Portland General Electric Company

Trojan Nuclear Plant
Docket 50-344
License NPF-1

On November 12, 1980, PGE submitted License Change Application (LCA) 67 requesting changes to the Trojan Technical Specifications regarding 41.6-kV emergency bus undervoltage protection. The letter provides supplemental information on the undervoltage protection system actuation logic.

Figure 1. PROPOSED UNDERVOLTAGE PROTECTION SCHEMES

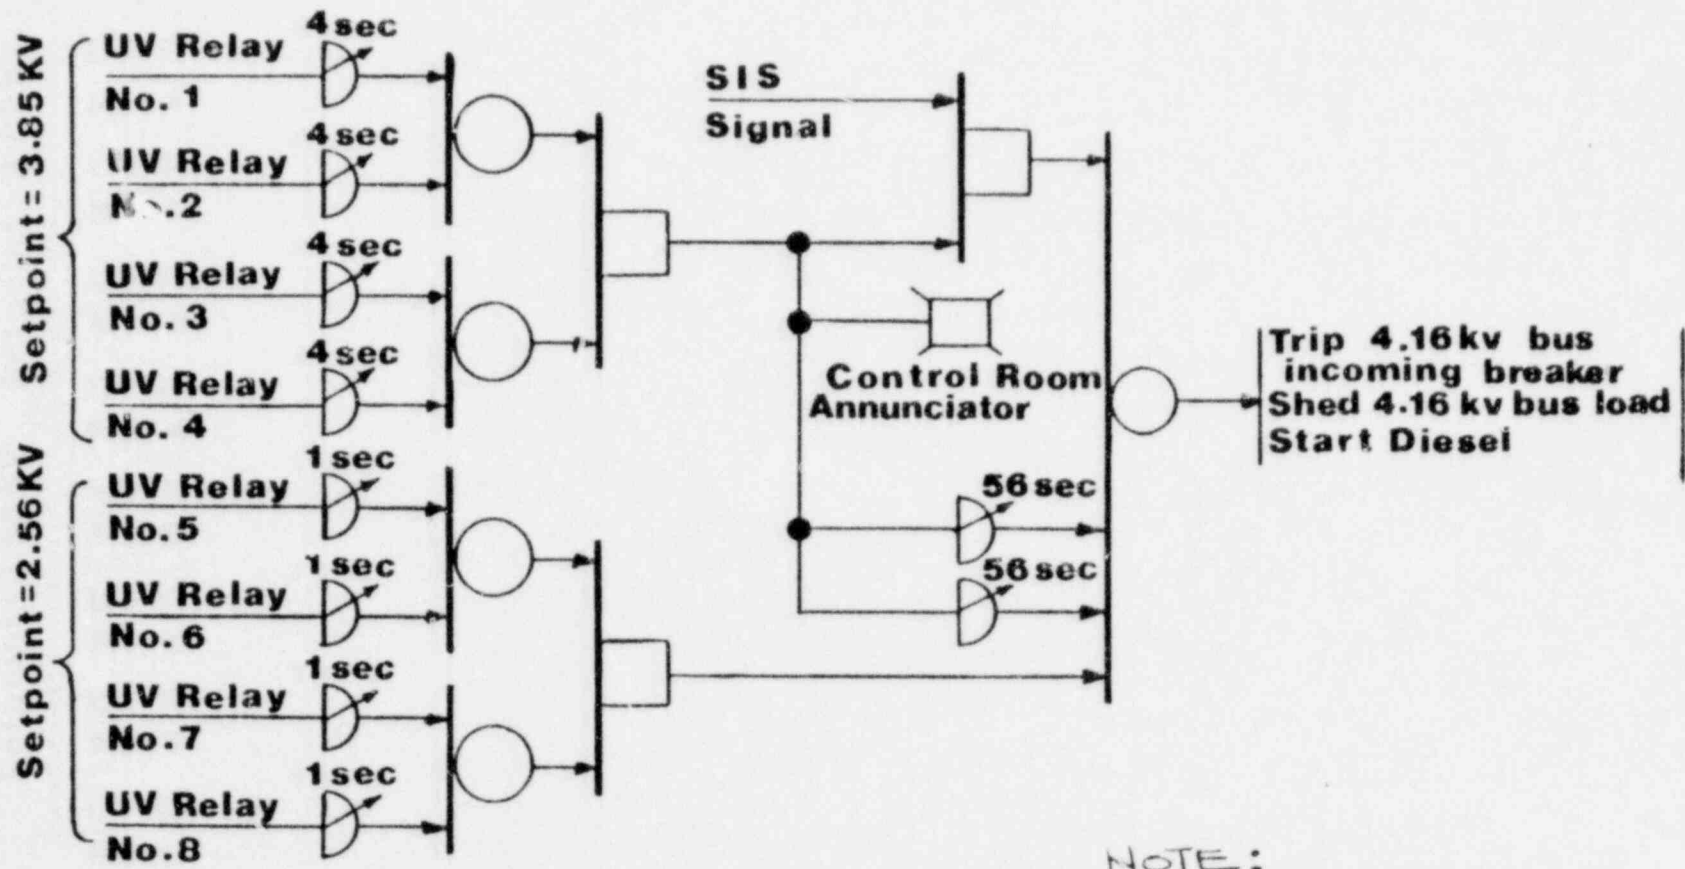
The primary undervoltage protection (loss of voltage) and the secondary undervoltage protection (degraded voltage) will each consist of a set of four solid-state definite time delay relays. The actuation logic to be implemented at Trojan is one-out-of-two-taken-twice among the four relays. This logic is presented in the attached Figure 1. Although the logic suggested by the NRC was either a two-out-of-three logic or a two-out-of-four logic, this one-out-of-two-taken-twice logic was chosen at Trojan based on the existing Plant condition and the expected improvement in system reliability.

FIGURE 2 INTERIM DRAWING CHANGE NOTICE

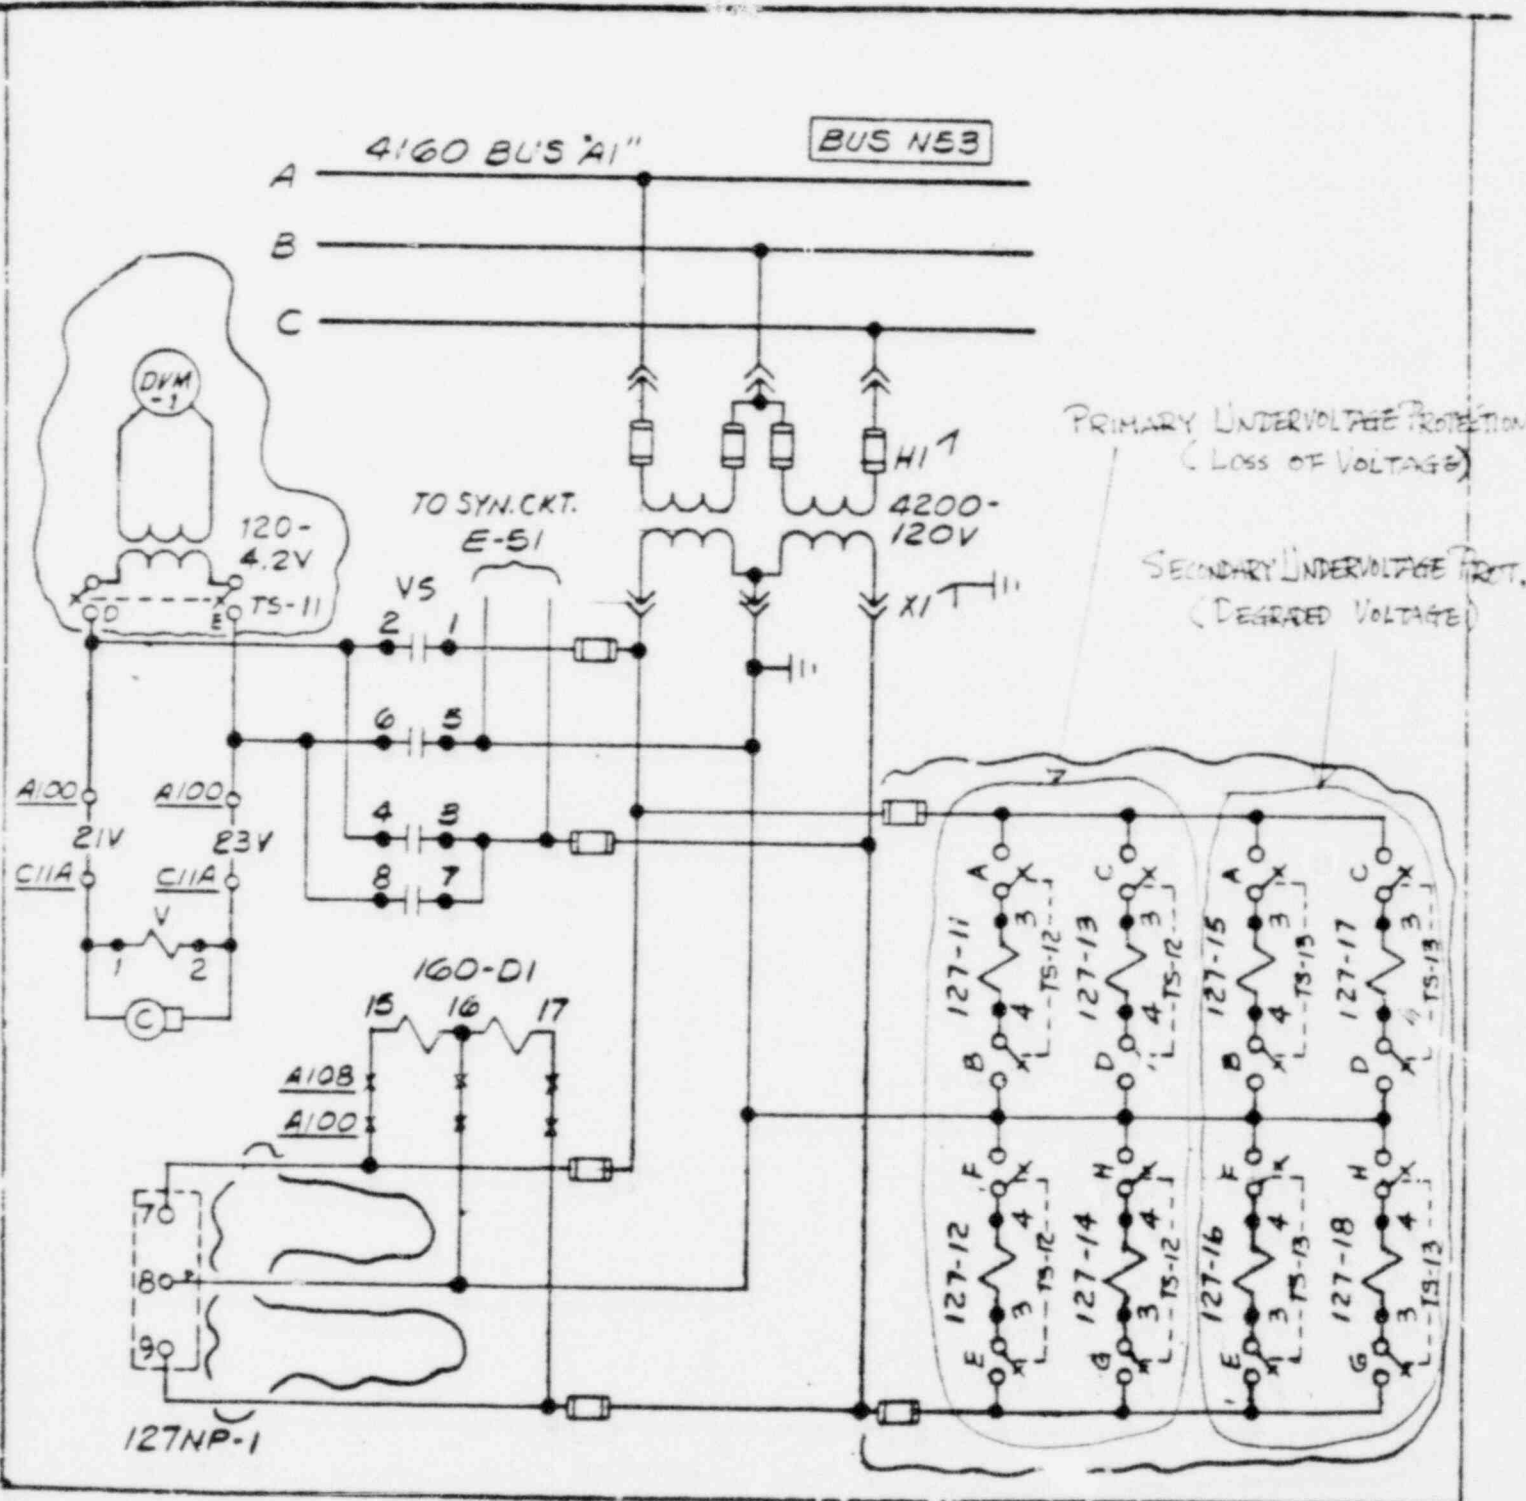
Trojan utilizes two potential transformers connected in an open delta configuration. Each potential transformer supplies two undervoltage relays and two degraded grid voltage relays as shown in the attached Figure 2 (Interim Drawing Notice E-203). If a fuse on one of the two potential transformers should blow, a two-out-of-four logic would open the breaker, thus actuating the undervoltage protection system. This is unacceptable since it would reduce the Plant reliability by causing an unnecessary challenge to the diesel generators and a possible plant trip. On the other hand, the proposed one-out-of-two-taken-twice logic does not cause the breaker to open since the logic requires an agreement between the two potential transformers before a trip can occur. Therefore, the Plant reliability will not be affected by a minor incident such as a blown fuse or failure of a potential transformer. It should be noted,

Reason for change: WRITTEN AGAINST REVISION 7 PER RDC 80-005
(DEGRADED GRID VOLTAGE)
